Comments of Chief Engineer/Mainland North, Drainage Services Department

Temporary Shop and Services for a Period of 5 Years,
Lot 283 S.A RP (Part) in D.D. 109, Kam Tin, Yuen Long,
New Territories

Drainage Proposal

主旨: 規劃申請A/YL-KTN/1291 提交補充資料

PROJECT: Temporary Shop and Services for a Period of 5 Years	TITLE PROPOSED DRAINAGE SYSTEM	FIGURE NUMBER FIGURE 3		
		VER	DESCRIPTION	DATE
LOCATION: Lot 283 S.A RP (Part) in D.D. 109, Kam Tin, Yuen Long, New Territories

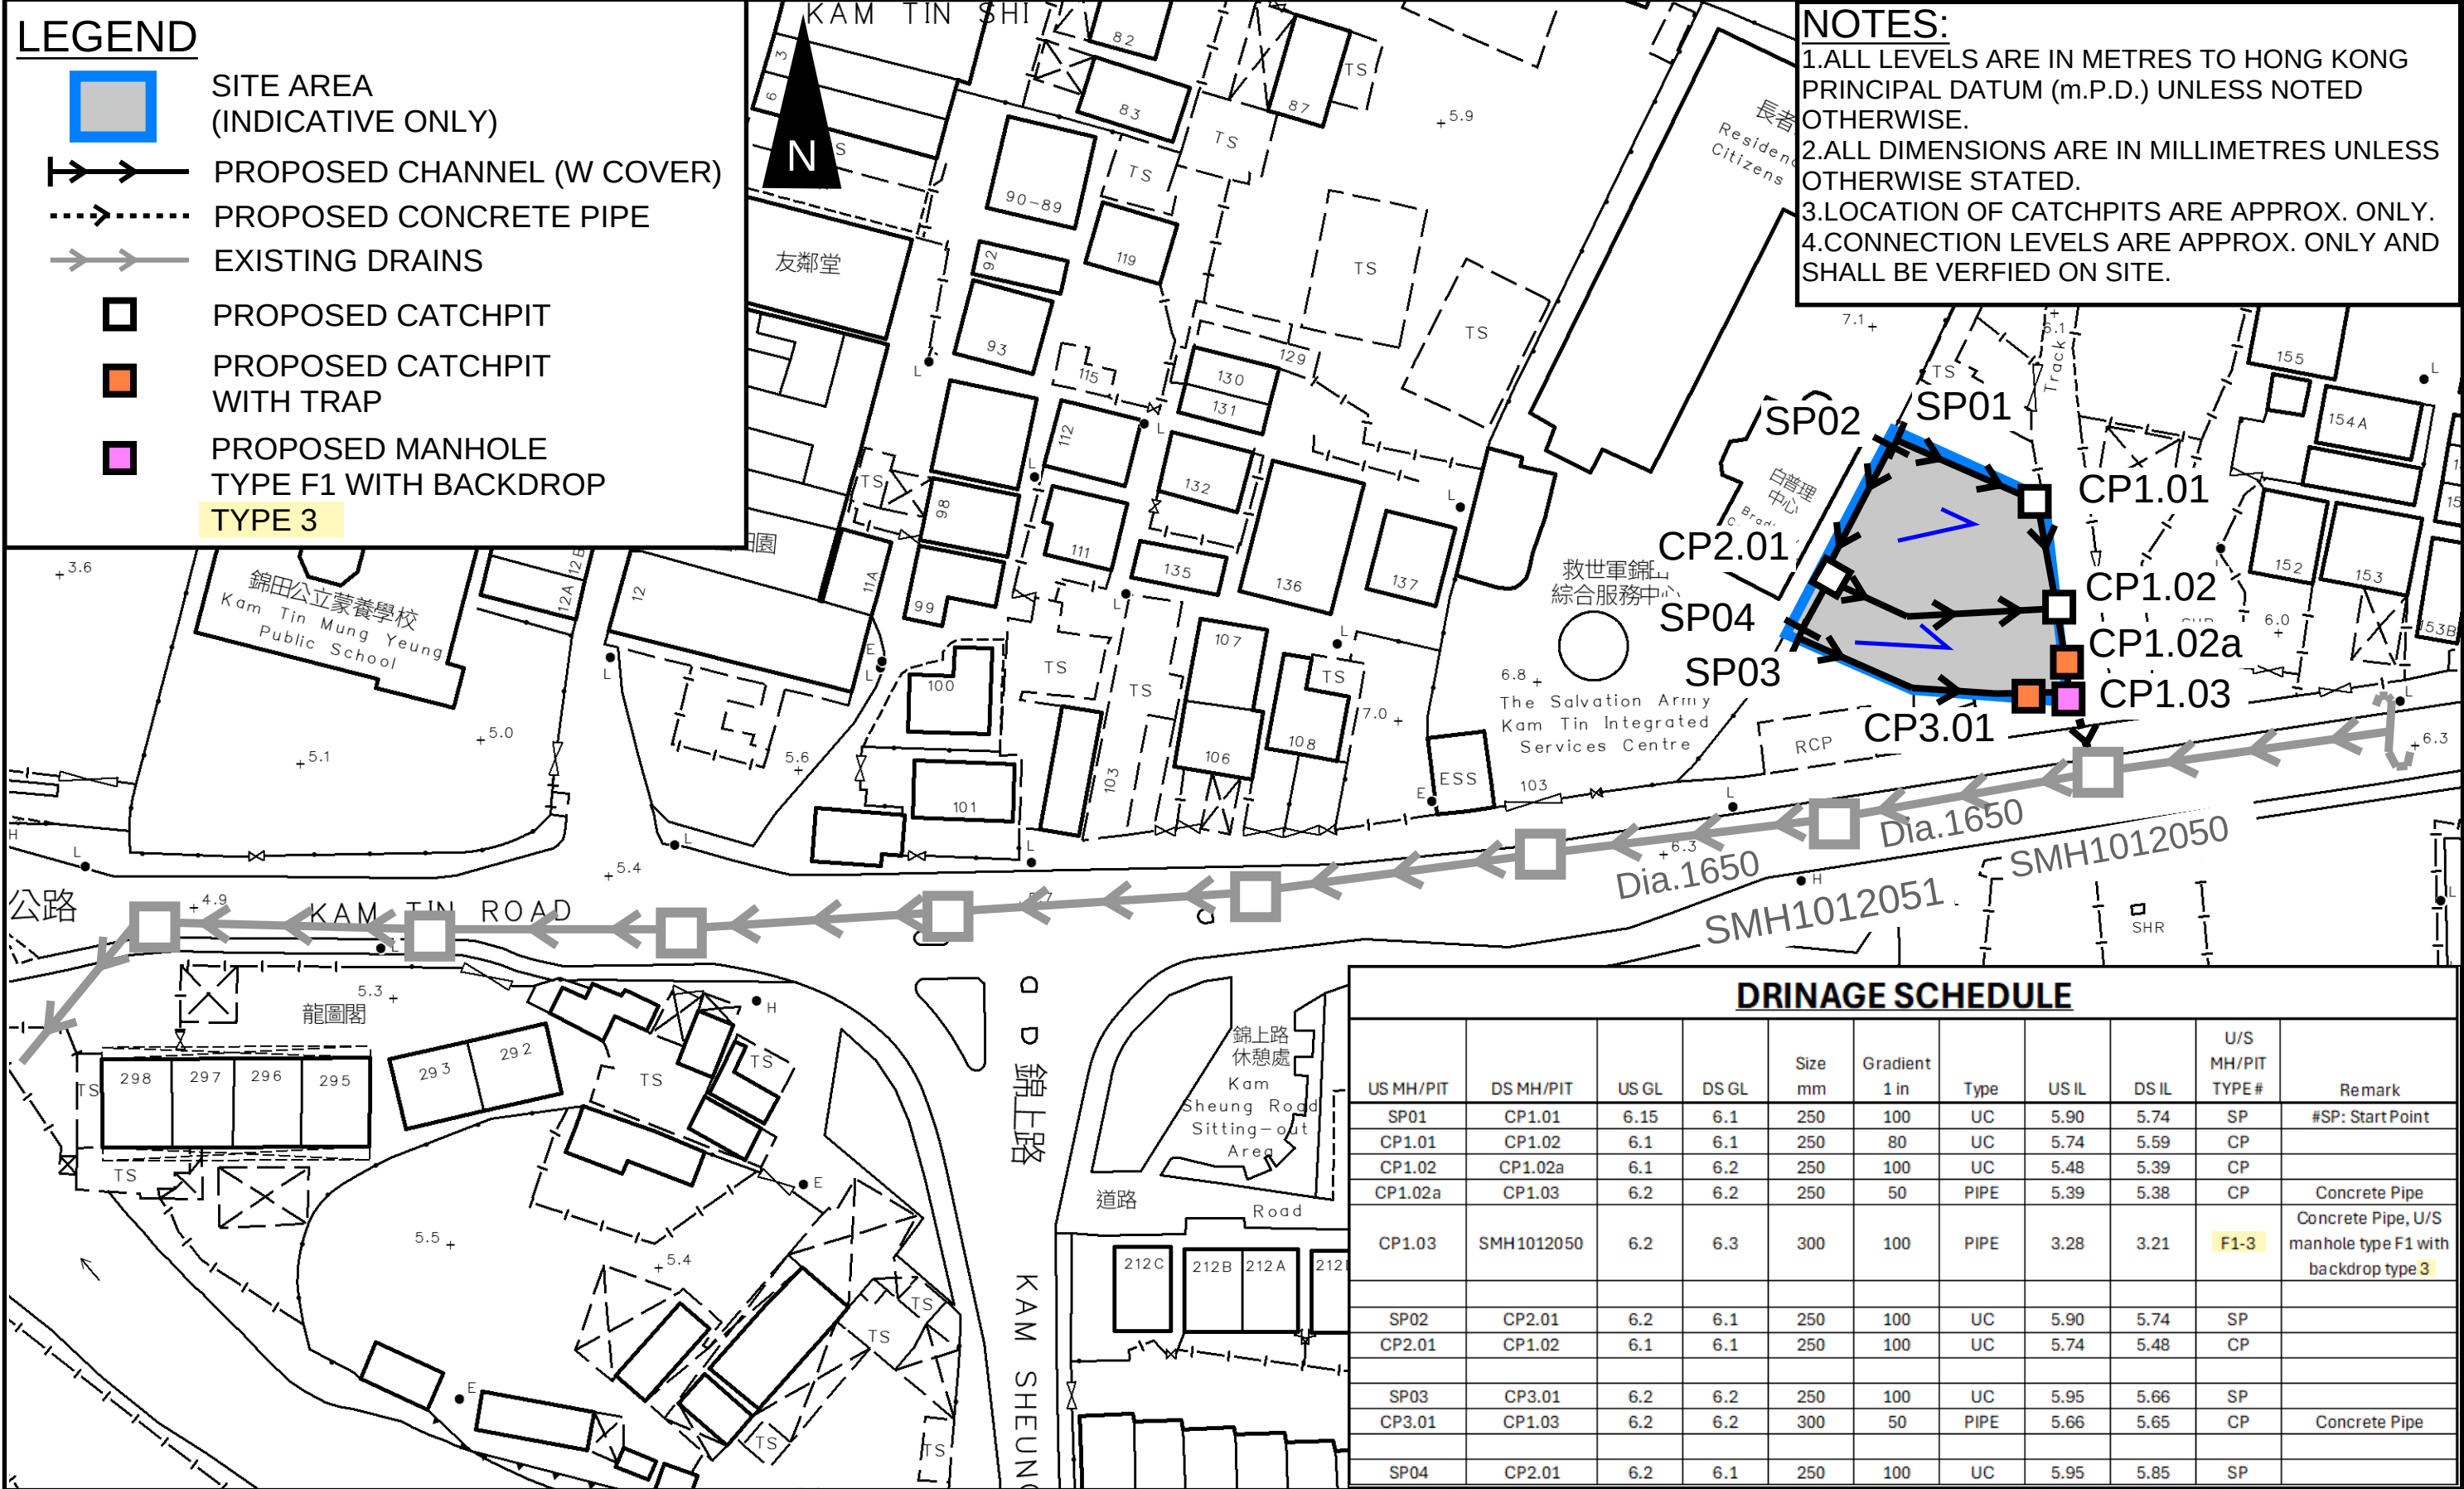
Item	Comments	Responses
A	Specific Comment	
1	Figure 3: The applicant should clarify discrepancies of invert levels of the proposed terminal manhole CP1.03 shown on the submitted drawing.	Noted. Further to the discussion with DSD, the manhole CP1.03 is revised to manhole type F1. The IL is updated in Figure 3.
2	The applicant should review construction details of the proposed terminal manhole CP1.03 since the proposed construction details were not applicable for backdrop manhole. Also, the applicant should review design of the proposed stormwater drainage system in order to minimize the need of adopting backdrop manhole.	Further to the discussion with DSD, sand traps are provided before connection to manhole CP1.03. As the existing manhole (SMH1012050) for connection is 3.6m depth, backdrop manhole is proposed to provide the enough drop in such short distance. The manhole CP1.03 to be maintained by the development. Standard drawings are shown in Appendix D.
